SERVICE BULLETIN

N° **139-684**

REV. : A - February 21, 2023

ATA 93 - TURRET FLIR UNIT REPLACEMENT

Figure 1

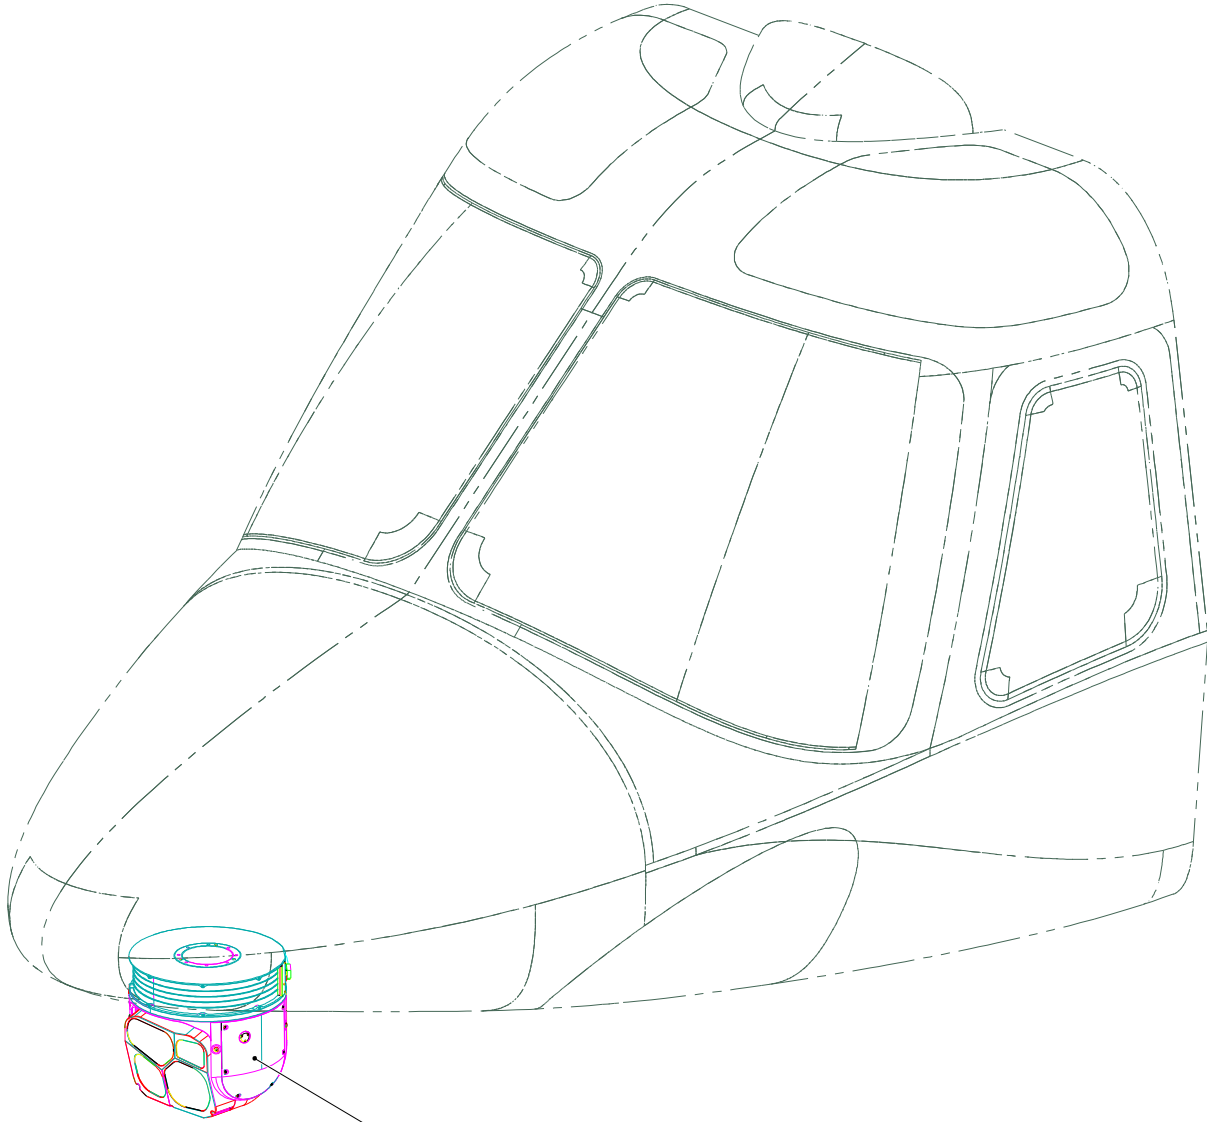
1. In accordance with AMP DM 39-A-00-20-00-00A-120A-A, prepare the helicopter on ground for a safe maintenance. Disconnect the battery, all electrical power sources and/or the external power supply.
2. With reference to Figure 1, gain access to the area affected by the installation and perform the TFU replacement as described in the following procedure:
 - 2.1 With reference to Figure 1, disconnect the connectors and remove the FLIR SS380 HDc TFU vendor control drawing P/N 3G9350I01231 from the helicopter. Retain hardware for later reuse.

REMOVE:
3G9350101231 FLIR SS380 HDC TFU VENDOR CONTROL DRAWING
INSTALL:
3G9350102031 FLIR SS380 HDC TFU VENDOR CONTROL DRAWING
(USE EXISTING HARDWARE)

Figure 2

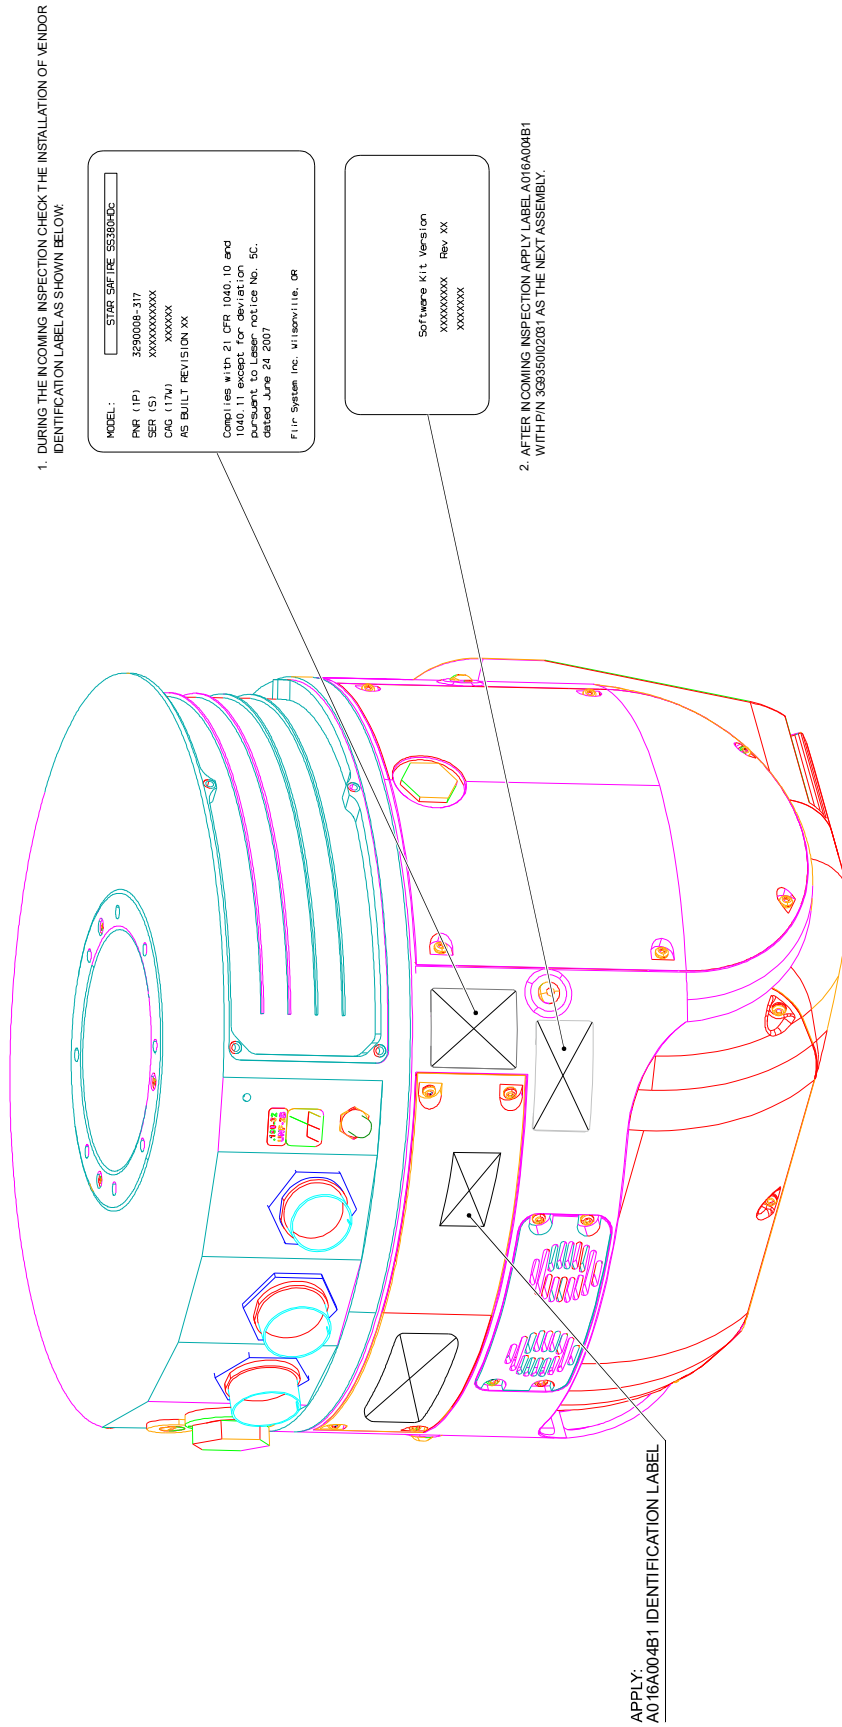
- 2.2 With reference to Figure 2, check the installation of vendor identification label.
- 2.3 After the inspection, apply label P/N A016A004B1 and, in accordance with CSPP DM CSPP-A-60-80-03-00A-691A-C, mark P/N 3G9350I02031 on it.
- 2.4 With reference to Figure 1, carefully lift the FLIR SS380 HDc TFU vendor control drawing P/N 3G9350I02031 until it is against the quick plate on its housing.
- 2.5 With reference to Figure 1, attach the FLIR SS380 HDc TFU vendor control drawing P/N 3G9350I02031 to the quick plate by means of existing hardware previously removed. Connect the connectors to the FLIR SS380 HDc TFU vendor control drawing.
3. In accordance with the applicable steps of AMP DM 39-B-93-55-00-00A-320A-K, perform the operations test of the FLIR STAR SAFIRE 380 HDc.
4. Return the helicopter to flight configuration and record for compliance with this Service
